**SUBDIVISION COMMITTEE
METROPOLITAN AREA PLANNING COMMISSION**

**STAFF REPORT
(Preliminary Plat)**

CASE NUMBER: S/D 89-68 - BILL BAILEY 2ND ADDITION

Re: S/D 89-68 BILL BAILEY 2ND ADDITION

PRELIMINARY PLAT
BILL BAILEY 2ND ADDITION

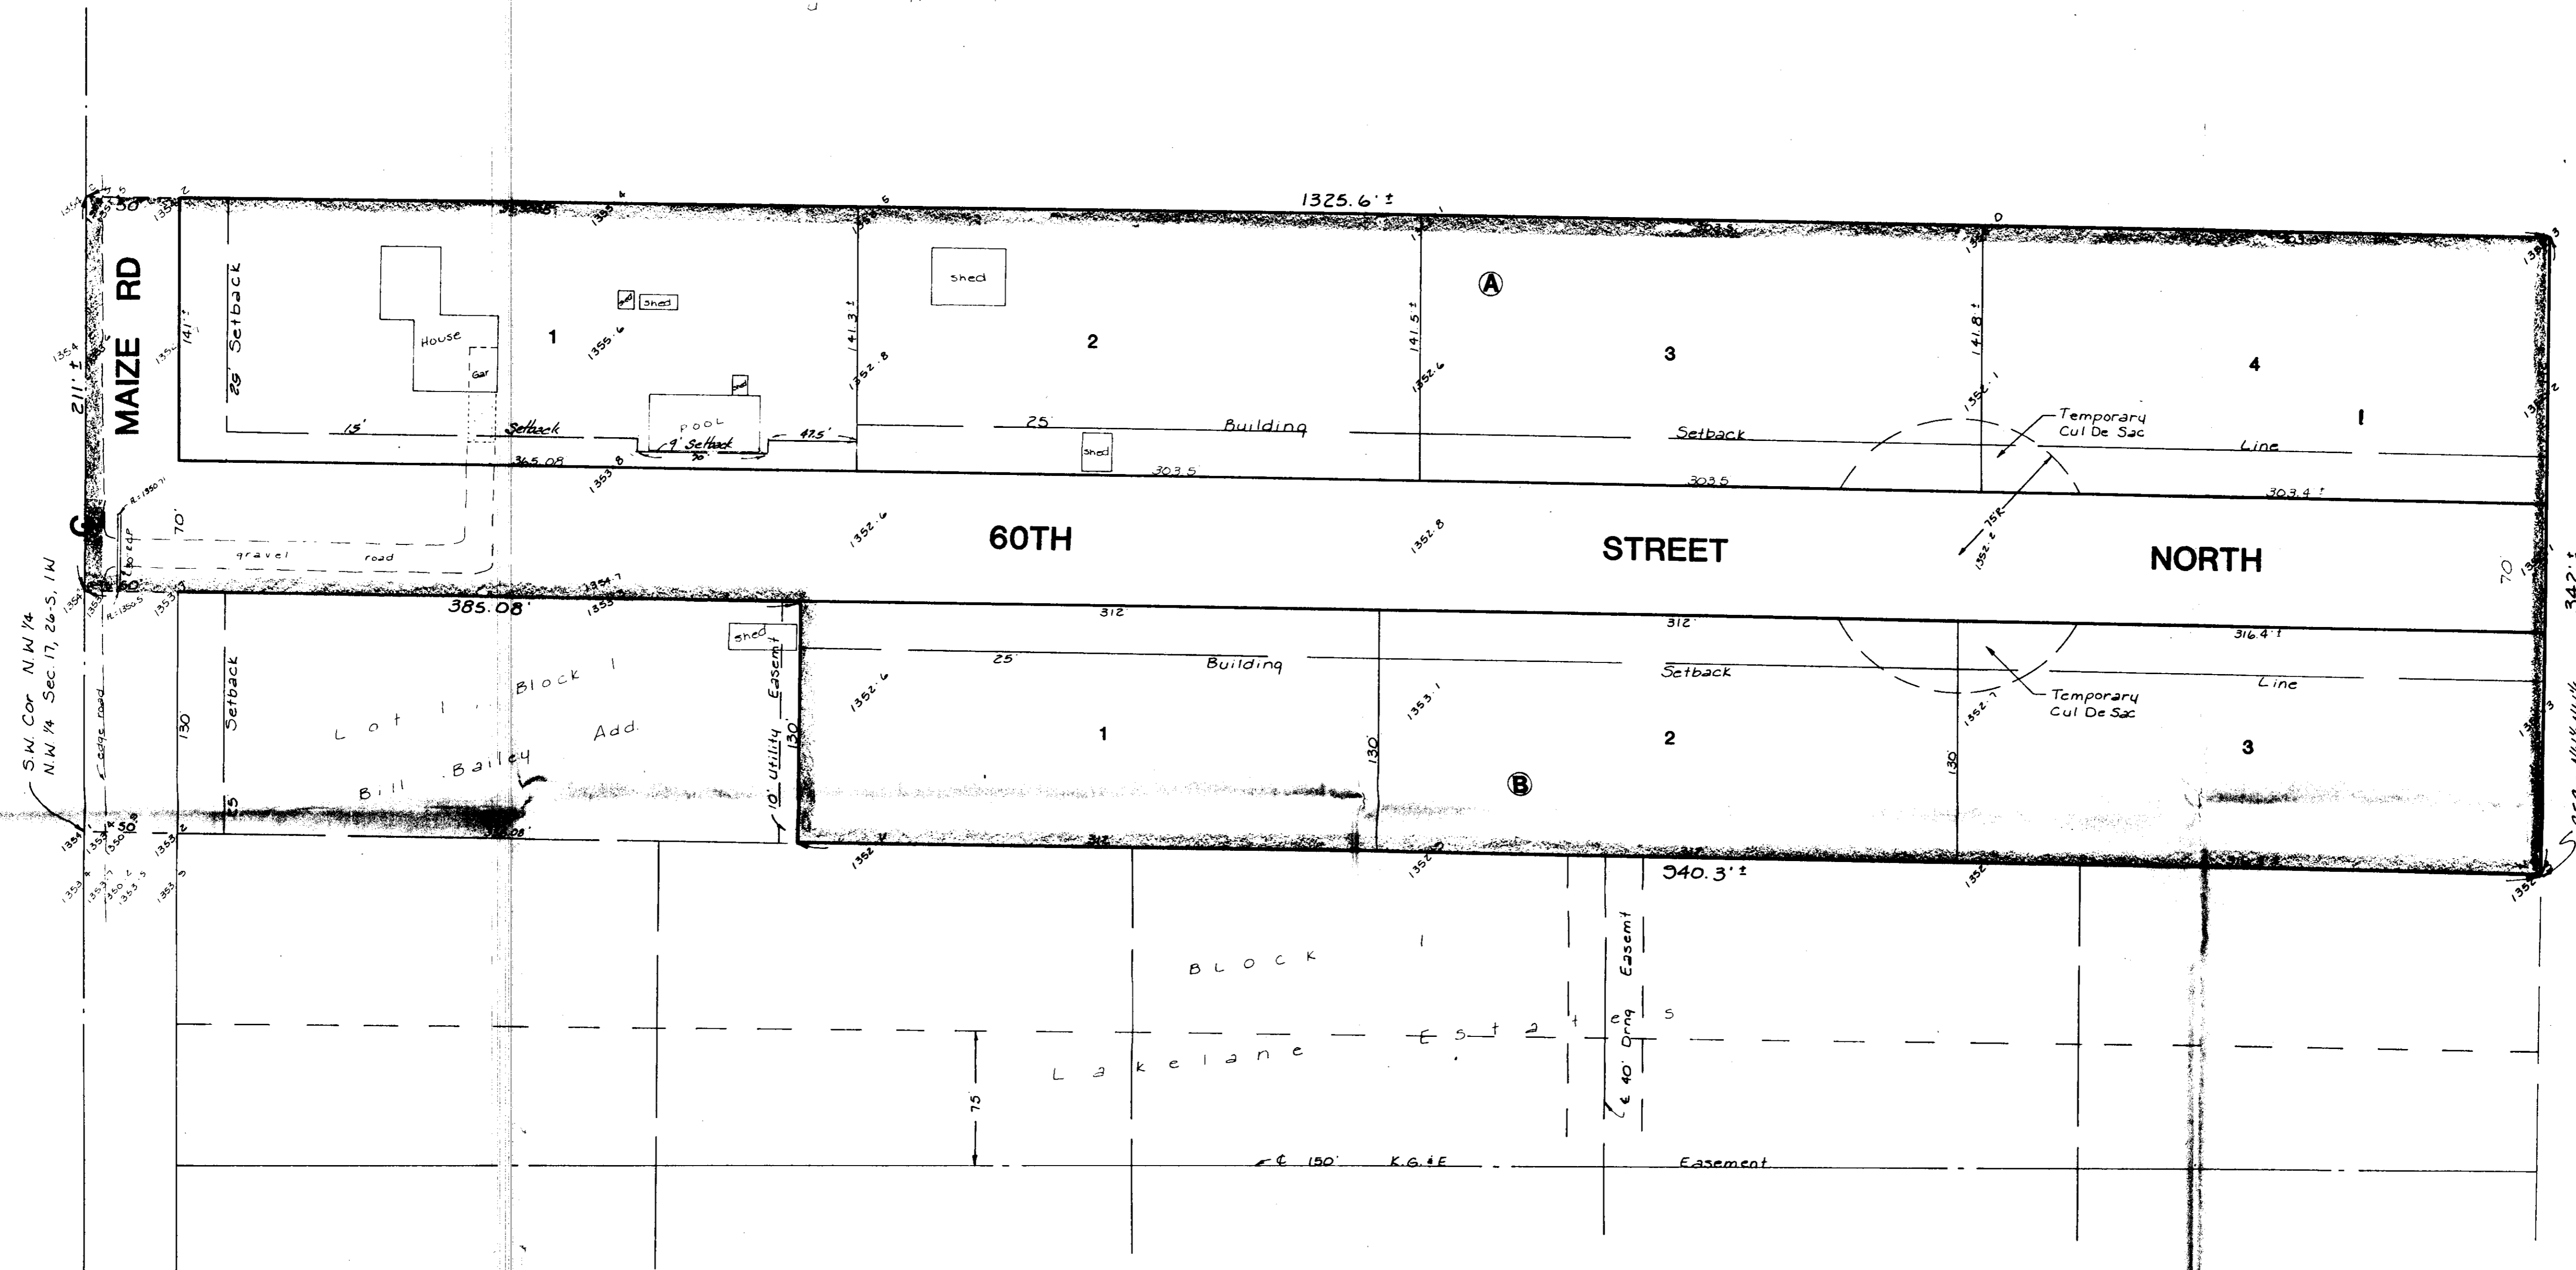
- E. On the final plat complete access control shall be indicated to Maize Road from the west line of Lot 1, Block A. The plattor's text shall state that the access control is being dedicated to the County.

- F. Lot 1, Block B shall also establish a 25-foot building setback to 60th Street. As indicated above and by the sketch plat, access to this site is by way of the proposed street. This setback maybe jogged around the existing pool.

- G. On the final plat tracing the cul-de-sac shall be indicated as temporary and the plattor's text shall indicate that this temporary cul-de-sac will be vacated when 60th Street North is extended east.

- I. As required by section 8-103(1), the final plat shall indicate the placement of irons at all corner's of this subdivision. A legend shall be added to the face of the plat which identifies the irons set and the irons found.
